ADDENDUM NO. 7

HVAC & CONTROLS REPLACEMENT/ADDITION AT NINE (9) SITES: BARRANCA, BEN LOMOND, CYPRESS, GROVECENTER, MANZANITA, MERWIN, MESA, ROWLAND, AND WORKMAN ELEMENTARY SCHOOLS RFQ/RFP #22-23-105

January 19, 2023

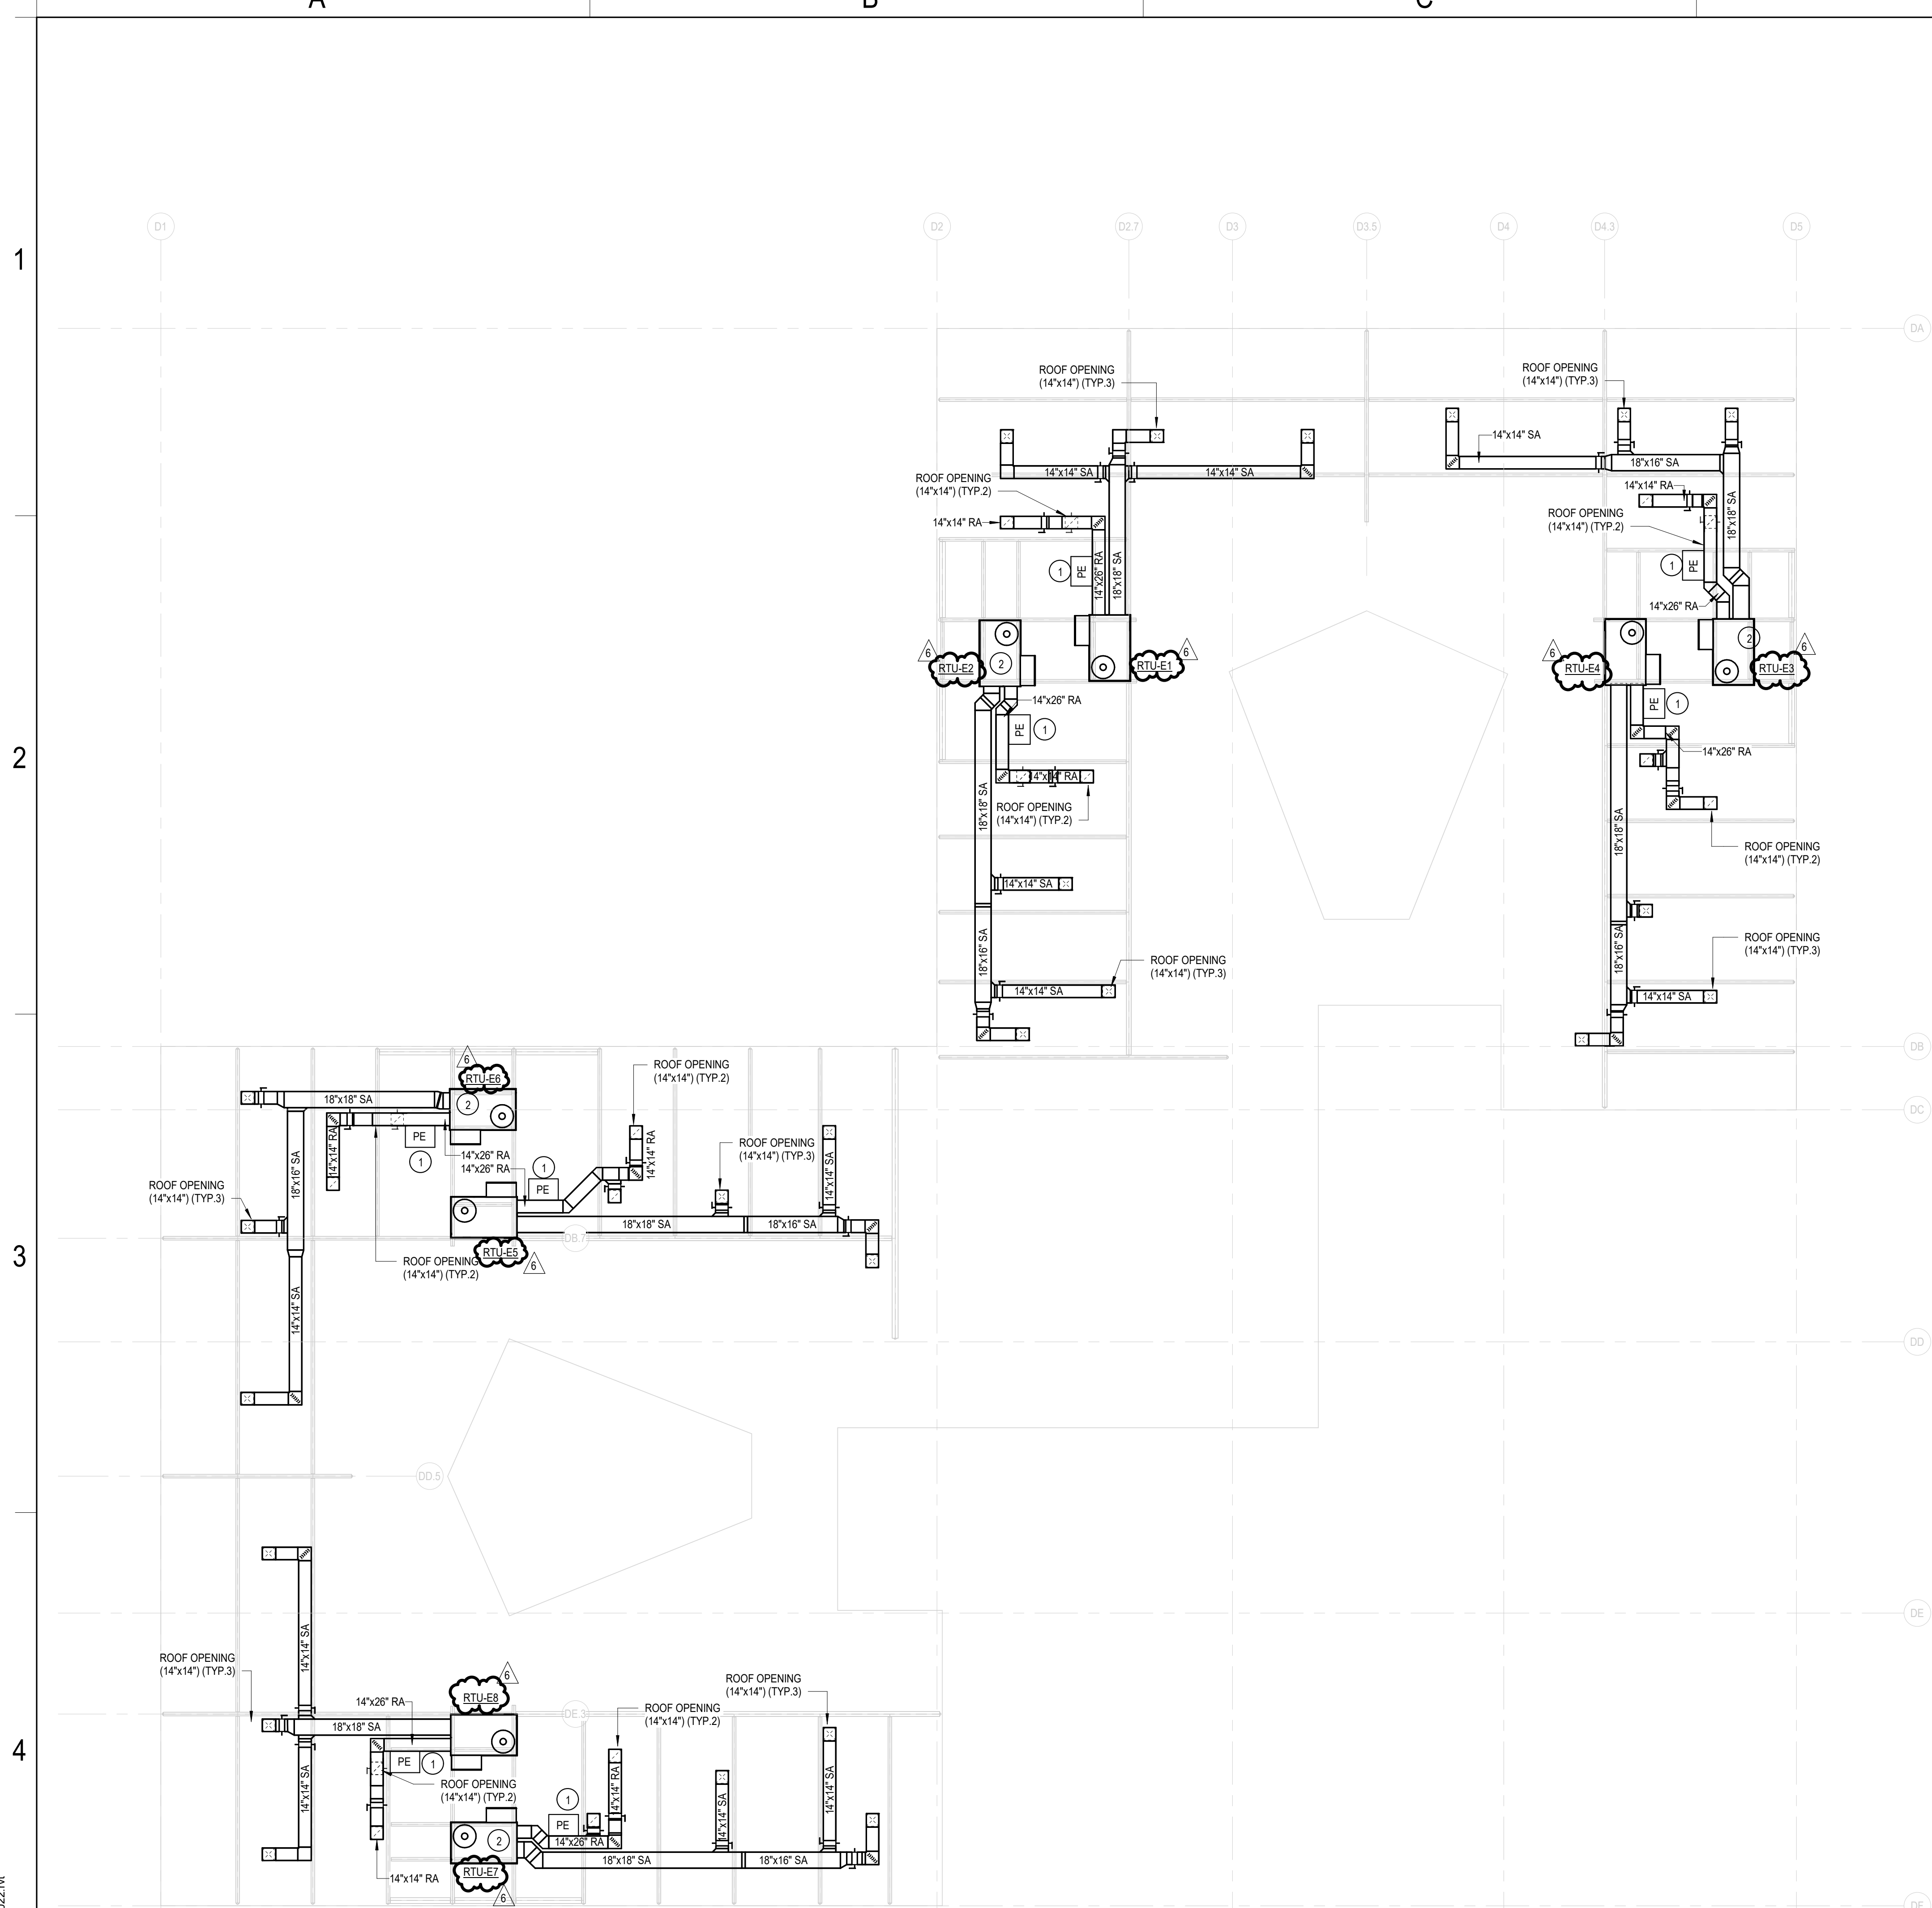
Key note D380 on the revised reflected ceiling plans indicate:
Demo (e) ceiling tiles to allow for mechanical duct work installation replace with (N) similar to existing. many of ceilings have an older style concealed spine ceiling that would be impossible to match, and would require an entire classrooms ceiling to be replaced.
Recomend replacing (e) concealed spline style ceilings with T Bar style ceilings.

Work will be done per plans.

M1.3E

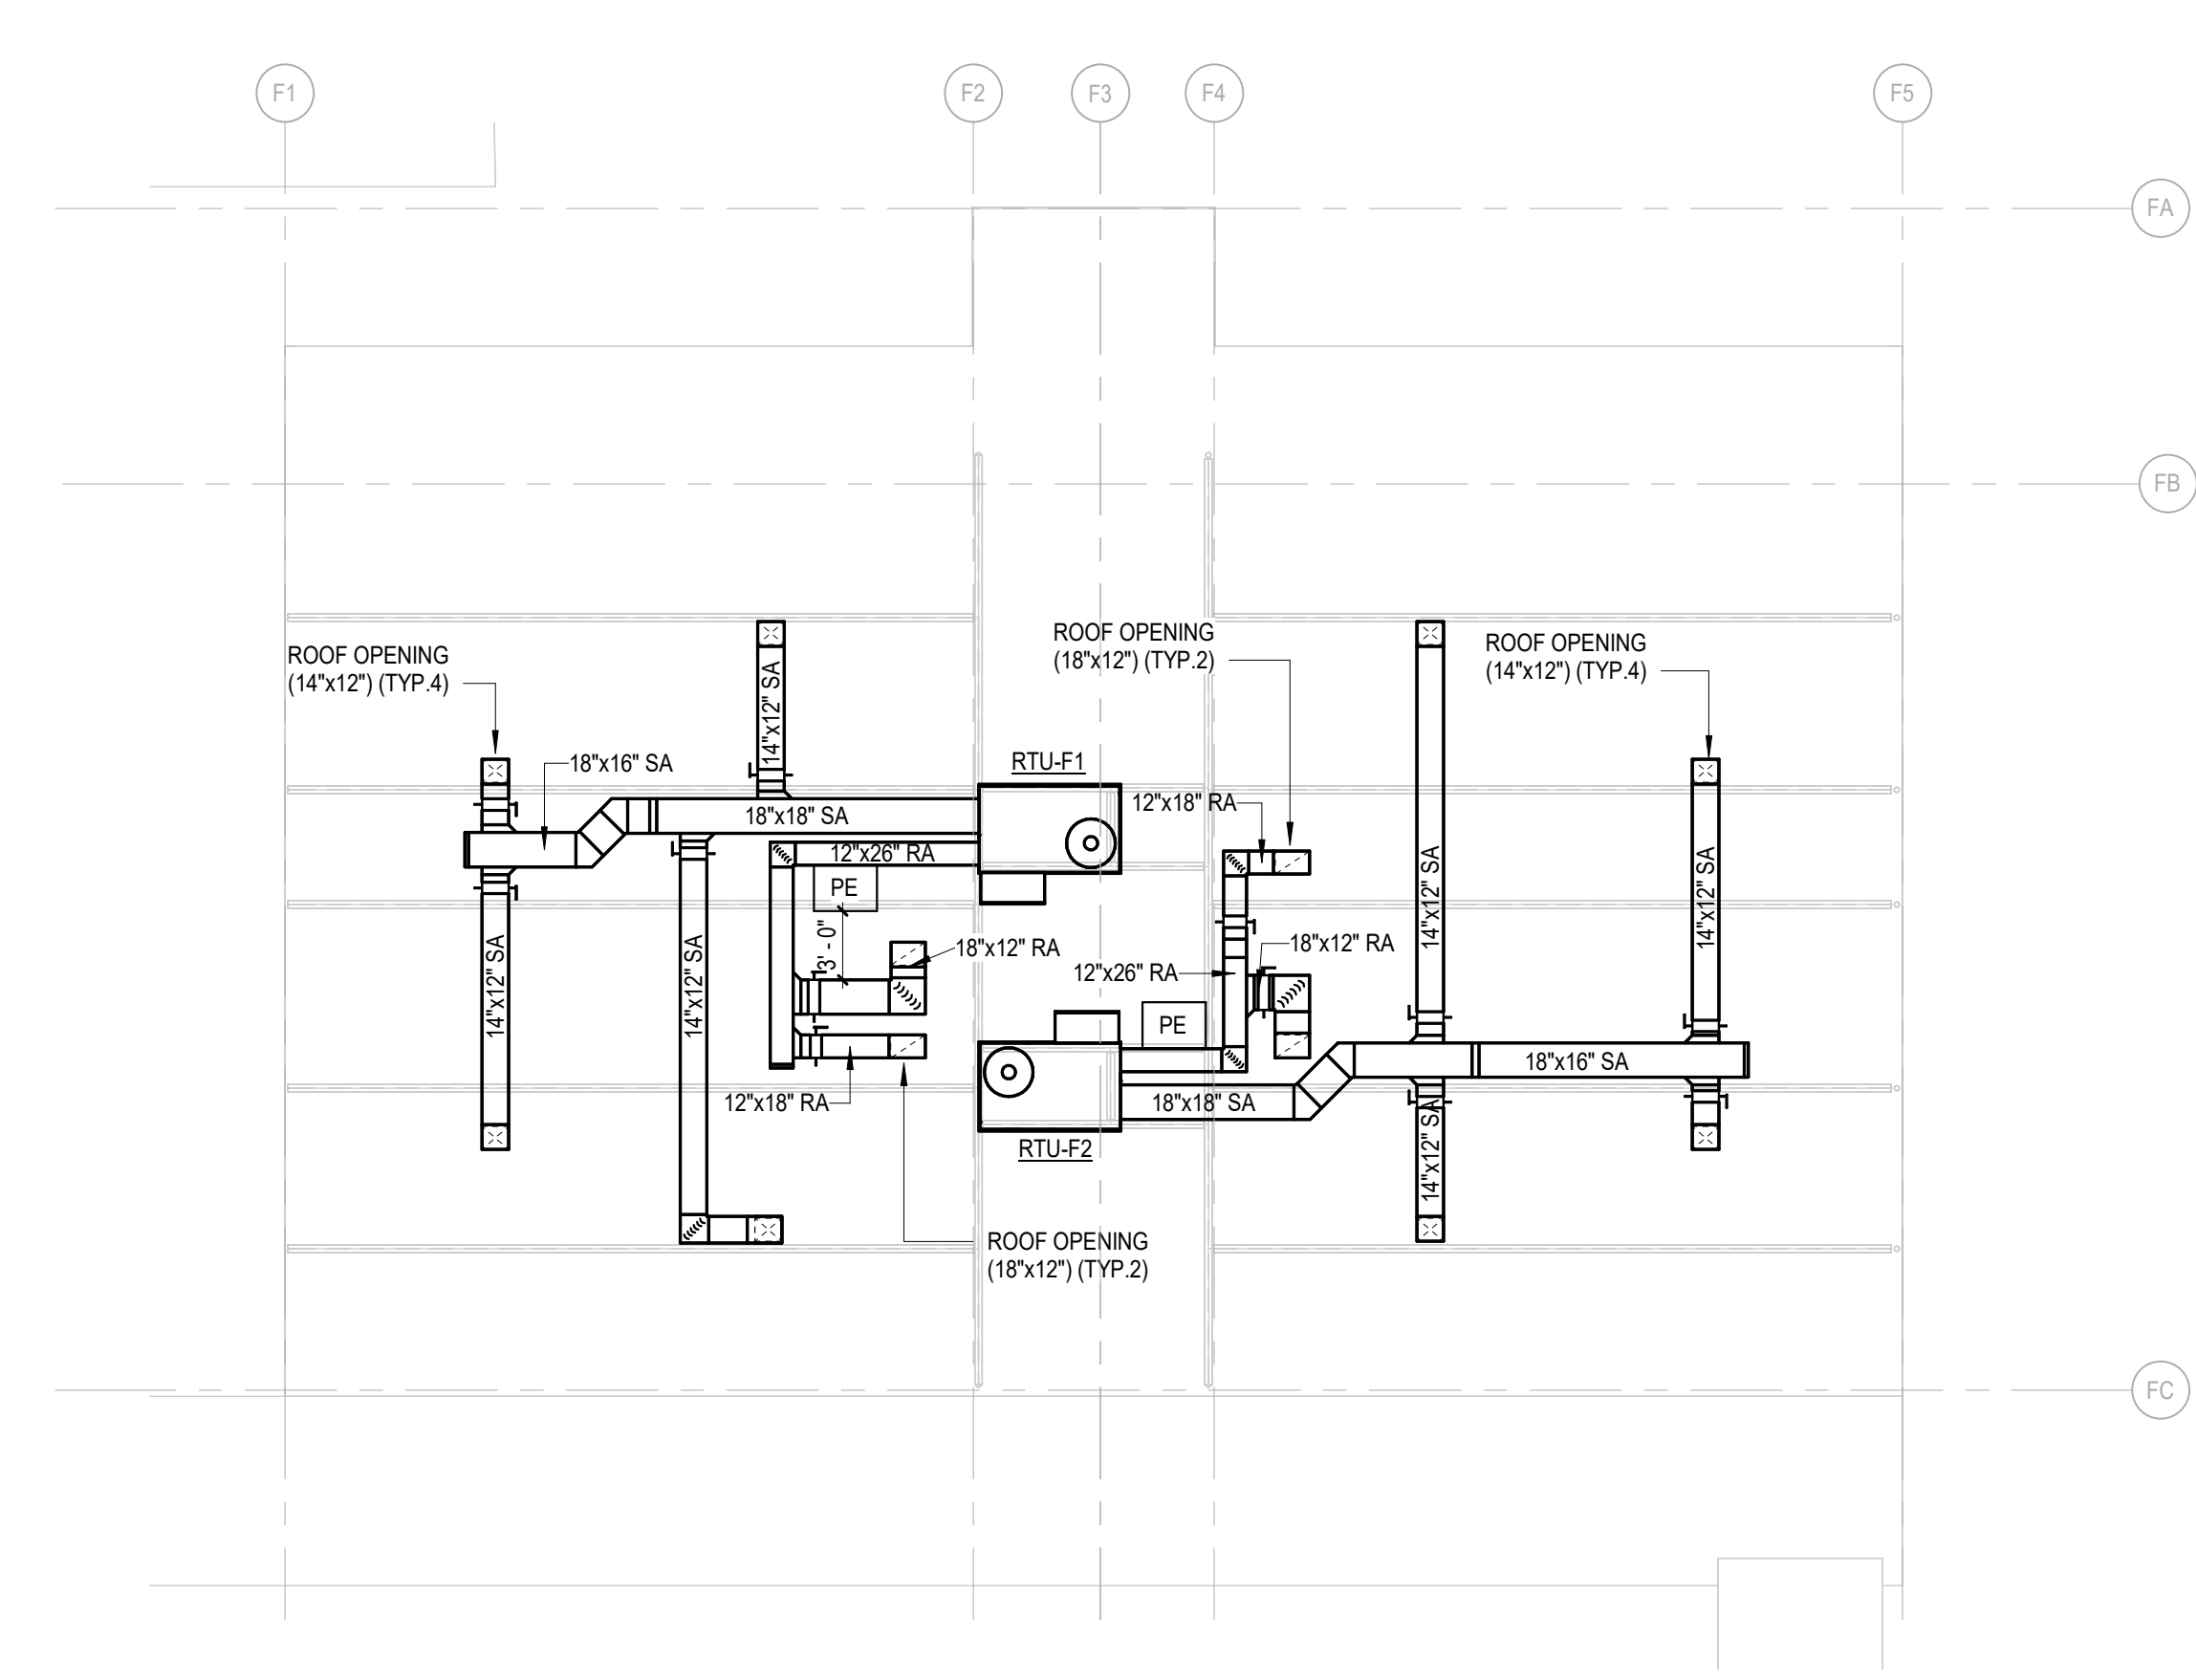
(Page M1.3E/M1.1E/M5.1)

-Building E or D? Per the Controls Riser Diagram and Roof/Floorplans the buildings don't match. Please confirm if building D or Building E is the building the that work will be preformed in.

DLR Response: Building E is the building in scope. See attached updated M1.3E & M5.1
